Decision 03-12-042 December 18, 2003

Application of the Alameda Corridor – East Construction Authority (ACE) for an order authorizing elimination of an existing at-grade crossing through construction of a grade separated crossing (roadway underpass) at Nogales Street, under Union Pacific Railroad Company’s Alhambra Subdivision main line, in the City of Industry, County of Los Angeles.

OPINION MODIFYING DECISION 02-11-012

NOGALES STREET GRADE SEPARATION
NOGALES ST. DETOUR ROAD
SIGNING AND STRIPING PLAN

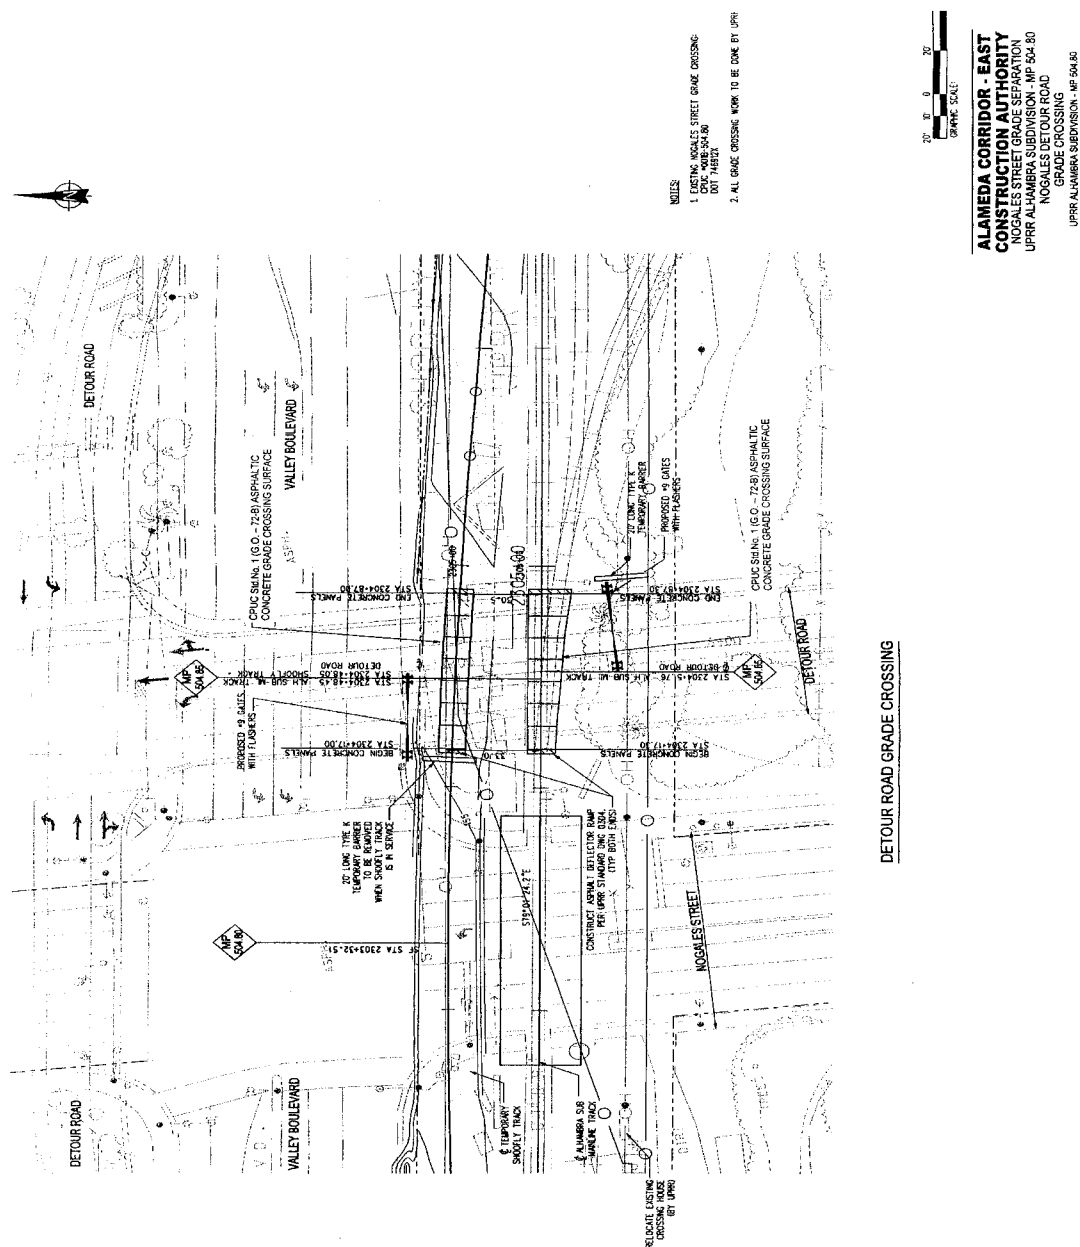
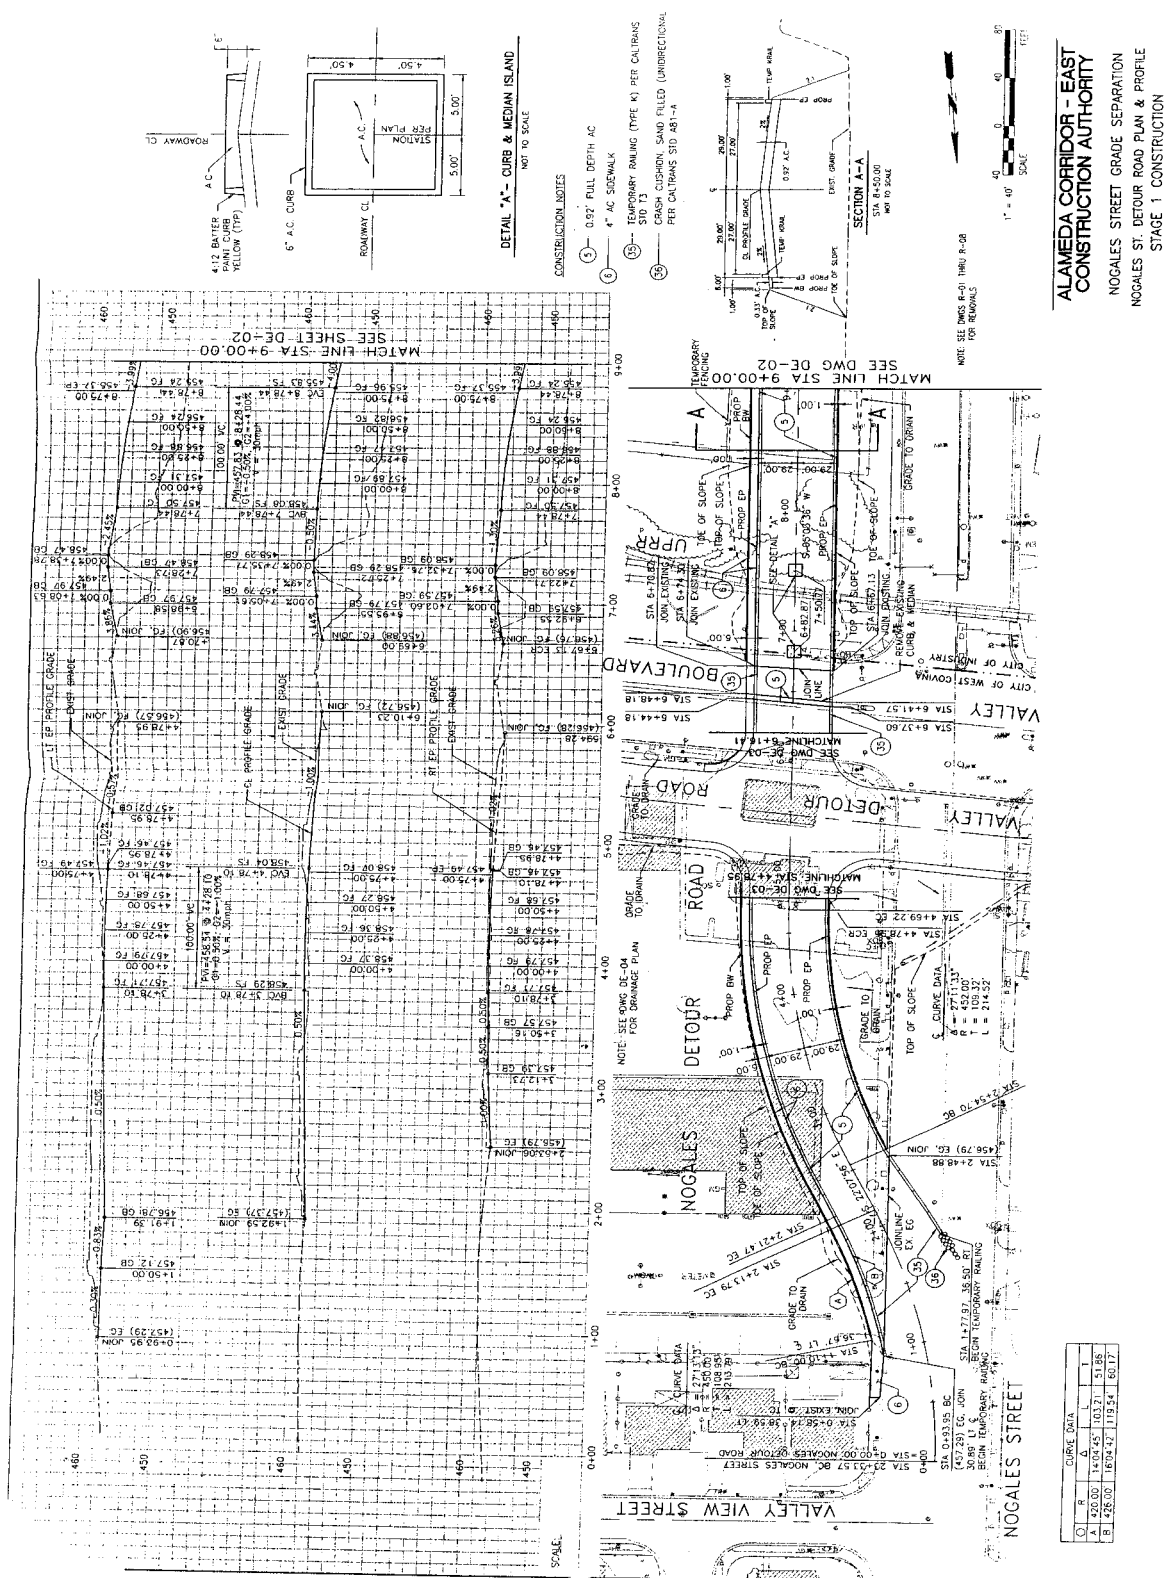
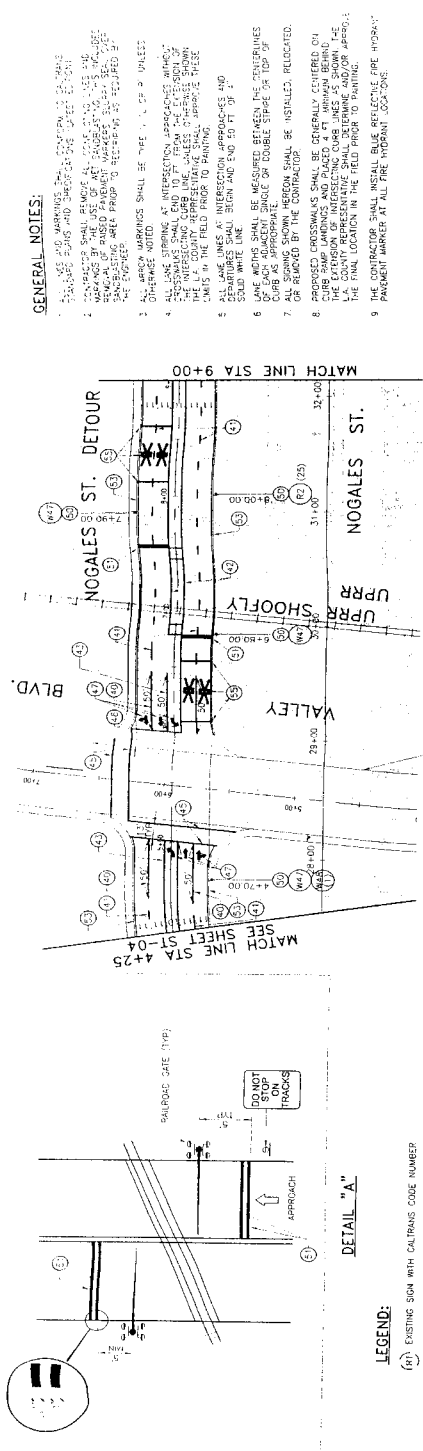
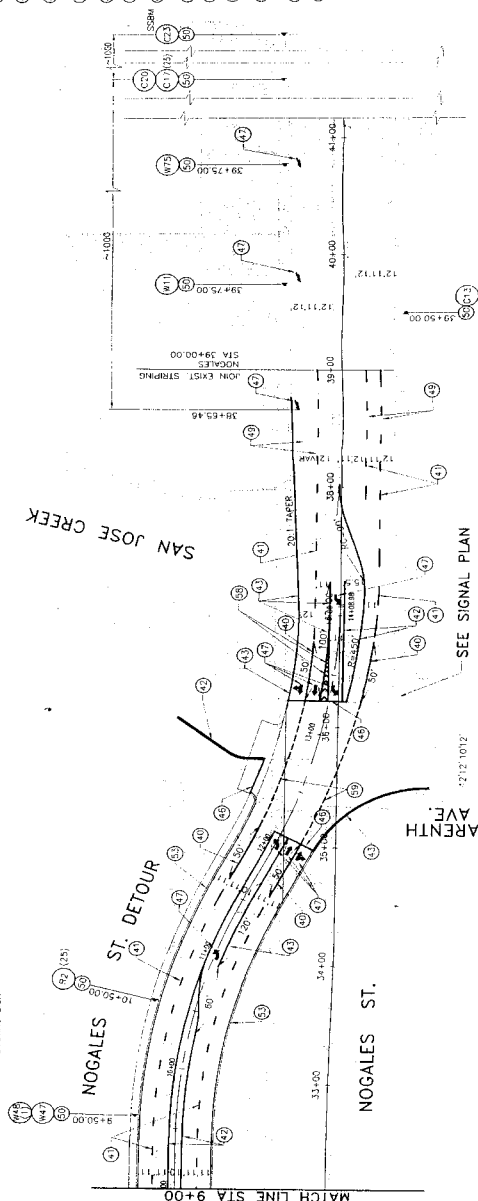
ACE filed the Petition for Modification of D.02-11-012 on September 9, 2003, to request a substitution to the type of warning devices at the proposed temporary detour at-grade highway-rail crossing. In A.02-01-038, ACE requested and in Ordering Paragraph 5 of D.02-11-012, the Commission ordered the installation of two CPUC Standard No. 9-A (flashing light signals with automatic gates with additional flashing lights on cantilevered mast arms, as defined in Commission General Order (GO) 75-C) warning devices and two CPUC Standard No. 9 (flashing light signals with automatic gates, as defined in GO 75-C) warning devices. In this Petition for Modification, ACE requests authority to install two CPUC Standard No. 9 and two median-mounted CPUC Standard No. 9 warning devices in lieu of the warning devices ordered in D.02-11-012.

2. The warning devices specified in D.02-11-012 are two CPUC Standard No. 9-A and two CPUC Standard No. 9 warning devices. The warning devices specified in this Petition for Modification are four CPUC Standard No. 9 warning devices (two warning devices located on the curbsides and two warning devices located on raised median islands).

1. Ordering Paragraph 5 is revised to read as follows: Alameda Corridor – East Construction Authority (ACE) shall install at the temporary detour at-grade highway-rail crossing, identified as CPUC Crossing No. B-504.87, four CPUC Standard No. 9 (flashing light signals with automatic gates, as defined in Commission General Order (GO) 75-C) warning devices (two warning devices on the curbsides and two warning devices each located on a raised median island), substantially as shown by plans attached to the Petition for Modification and Appendix of this order.
